DUKE POWER COMPANY  
OCONEE NUCLEAR STATION

ATTACHMENT 1

### 3.7 AUXILIARY ELECTRICAL SYSTEMS

Technical Justification

Figure 1

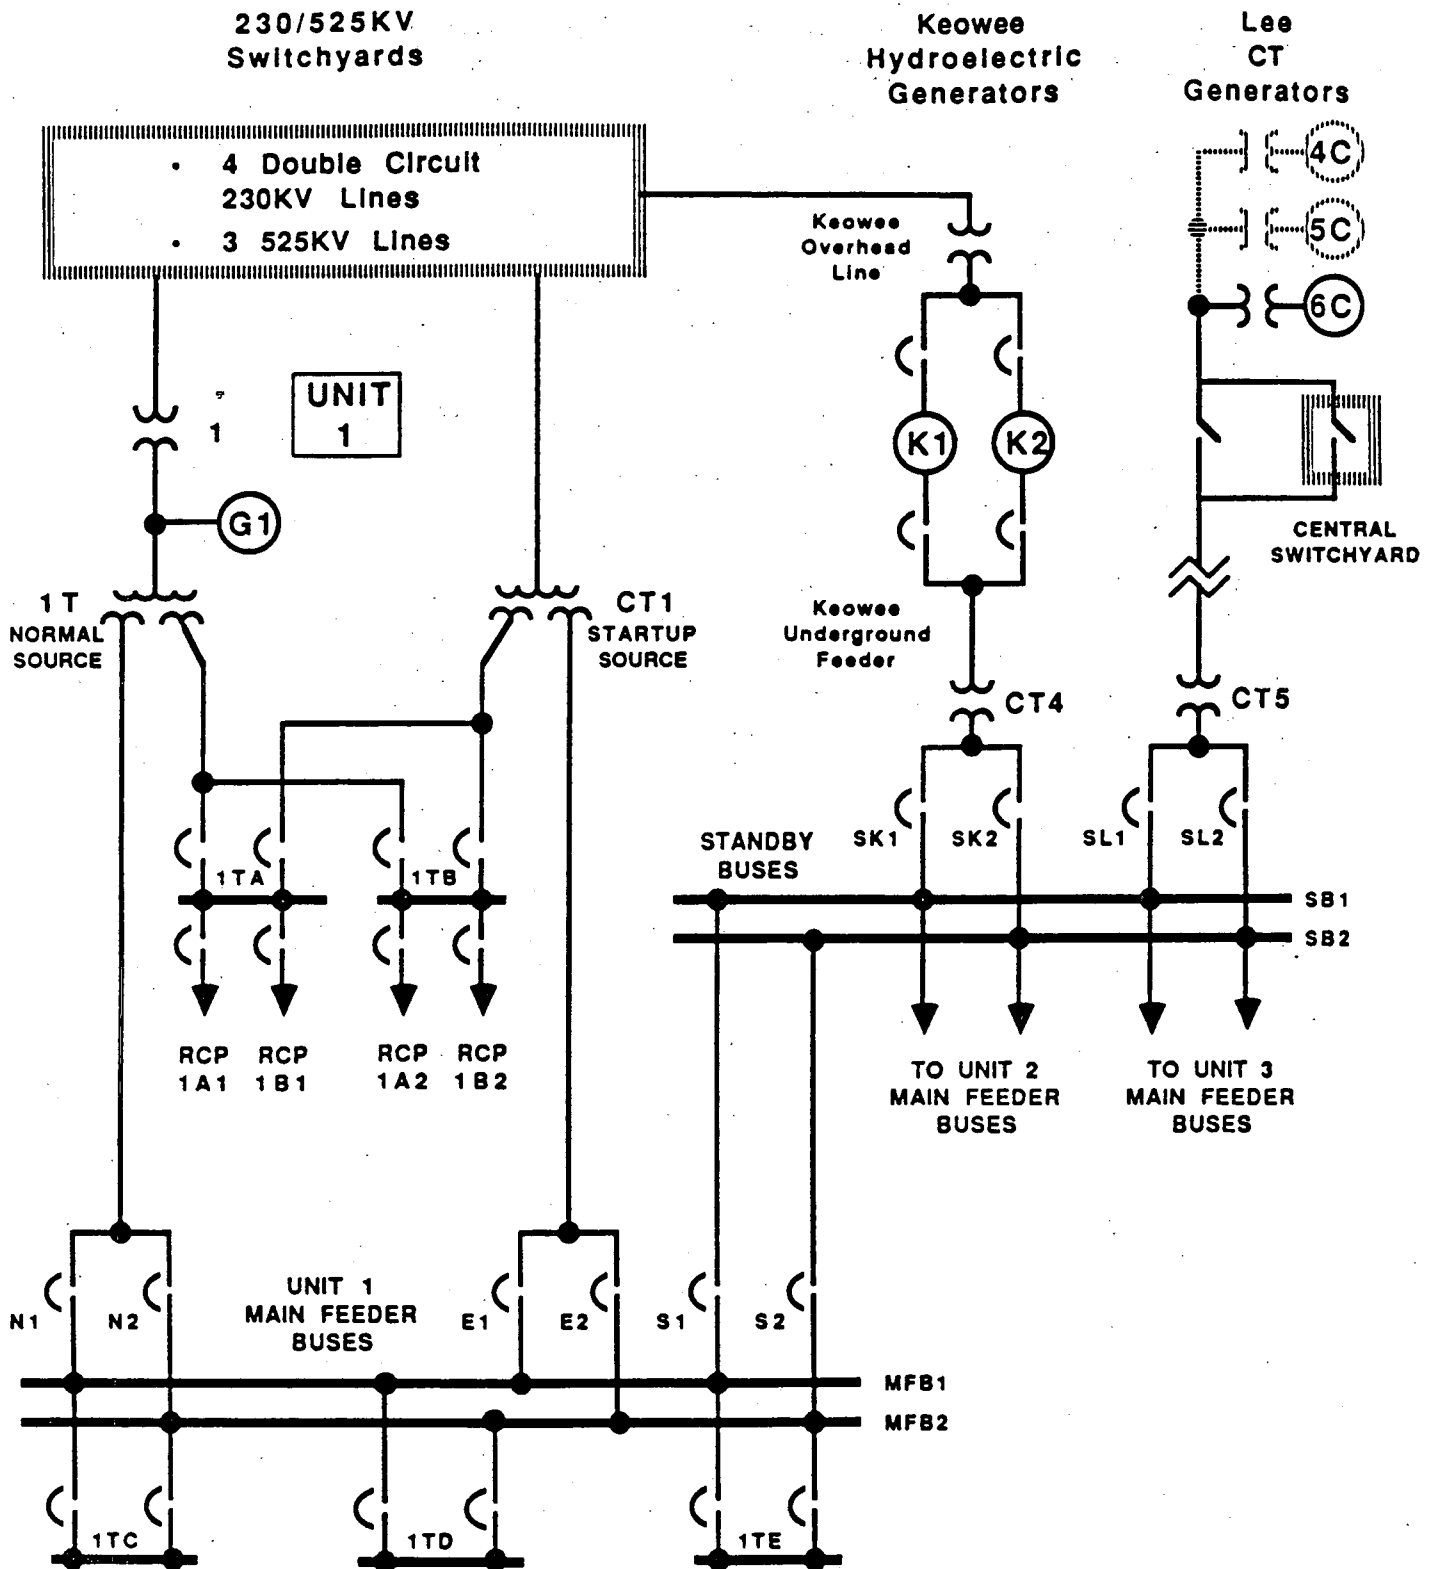
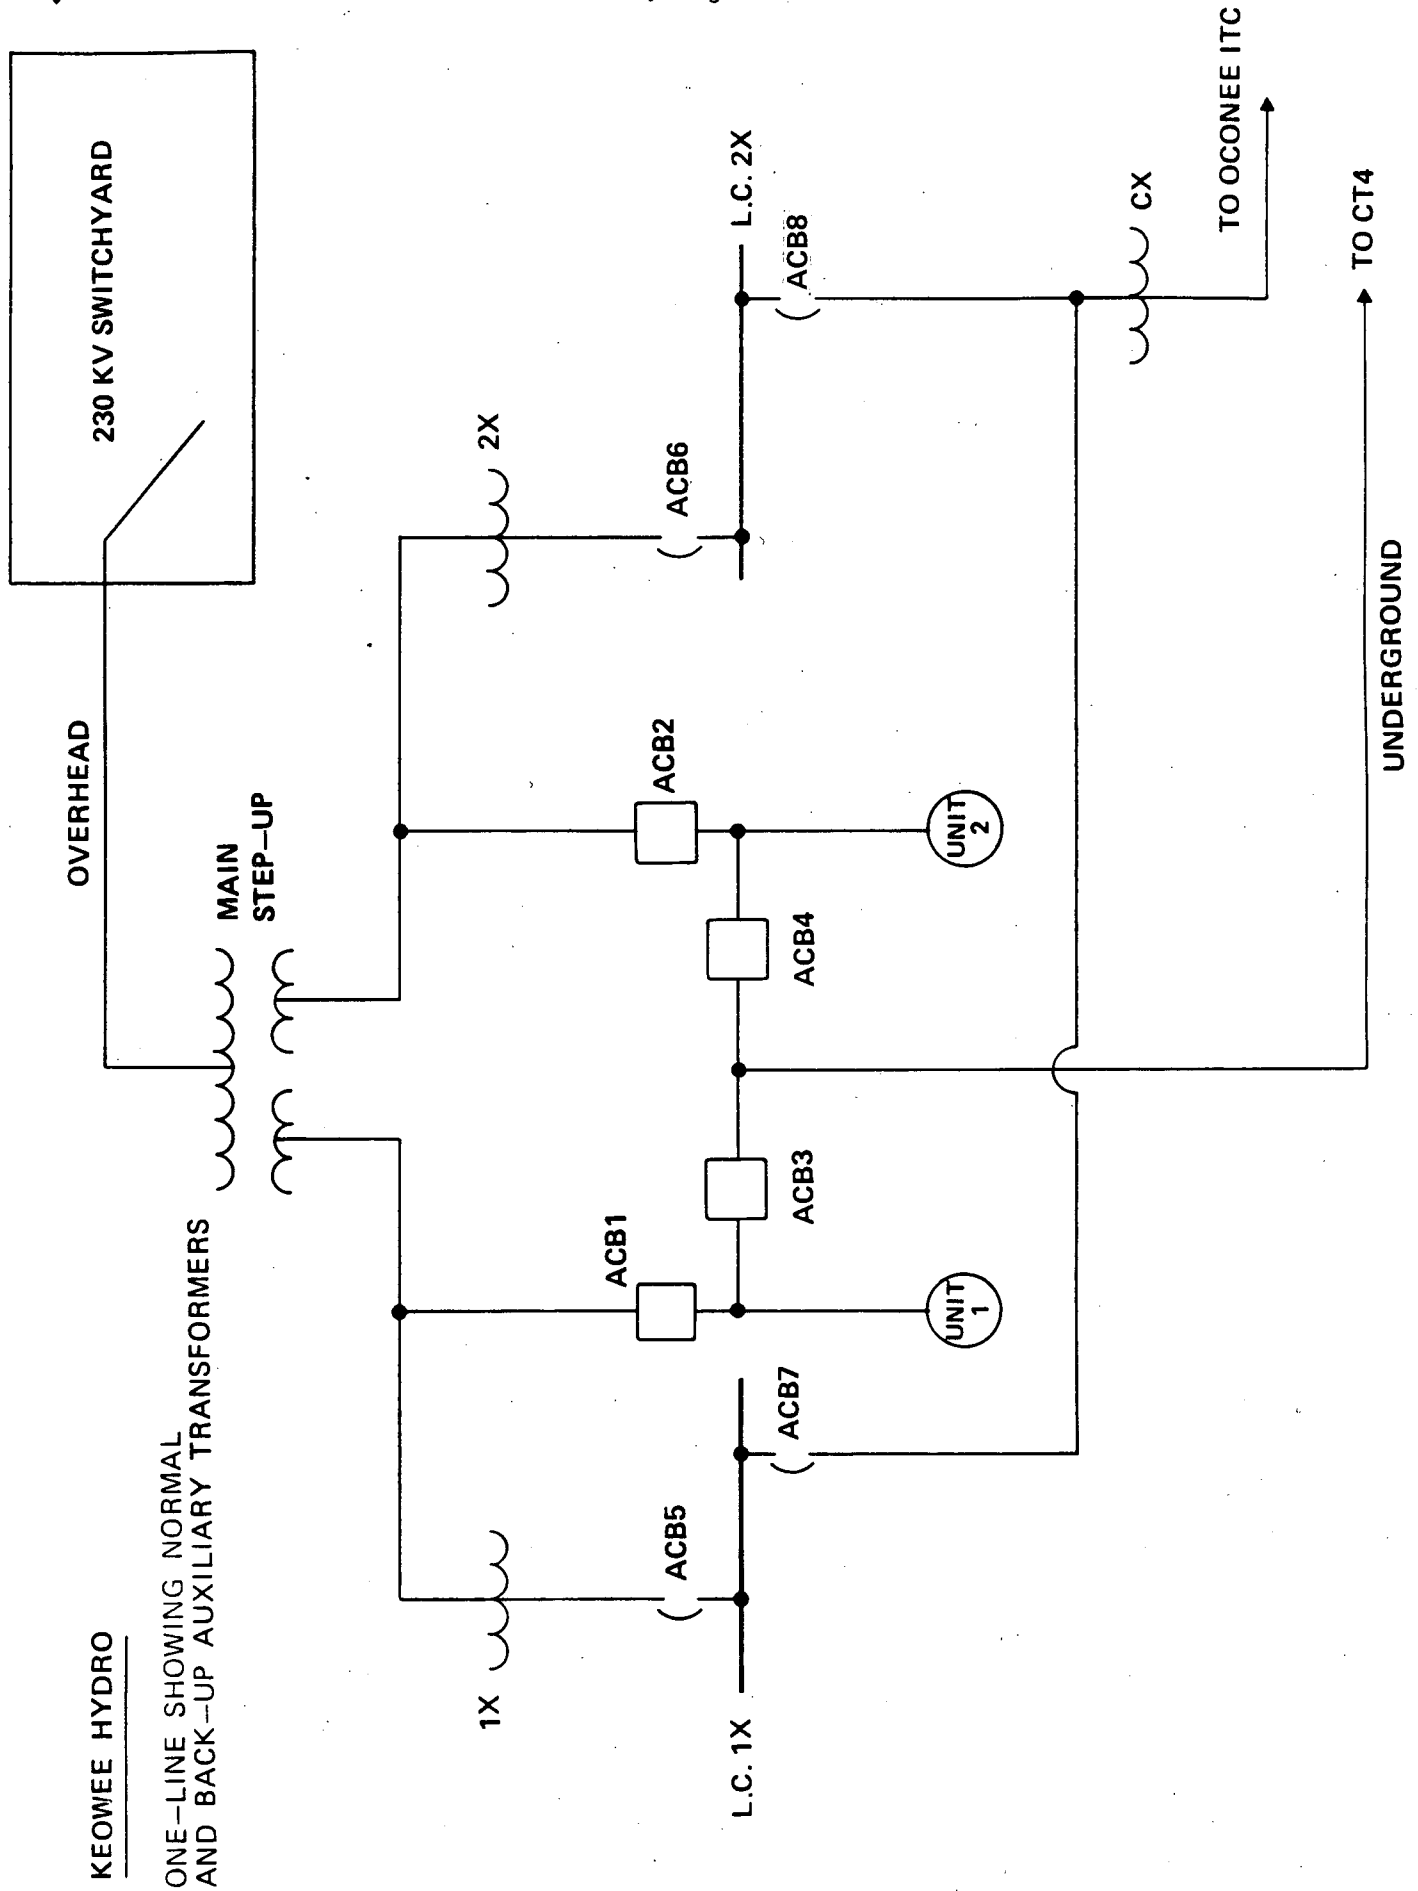
The EPSL in conjunction with its associated circuits, provides a means for assuring that power is supplied to the main feeder buses and therefore to the essential plant loads under accident conditions. The EPSL monitors the normal and emergency power sources and upon loss of the normal power source, the EPSL will seek an alternate source of power. The first priority as the alternate power source is the unit startup transformer powered from either the plant 230 kV switchyard or from one of the Keowee hydro units via the 230 kV overhead feeder. In the event the startup source is not available, the EPSL will select the standby bus as the alternate power source with power provided from an emergency power source (the other Keowee hydro unit via the 13.8 kV underground feeder). If none of the alternate power sources are available, the EPSL waits until power is available at one of the sources and then selects that source as the emergency power supply. (See figure 1)
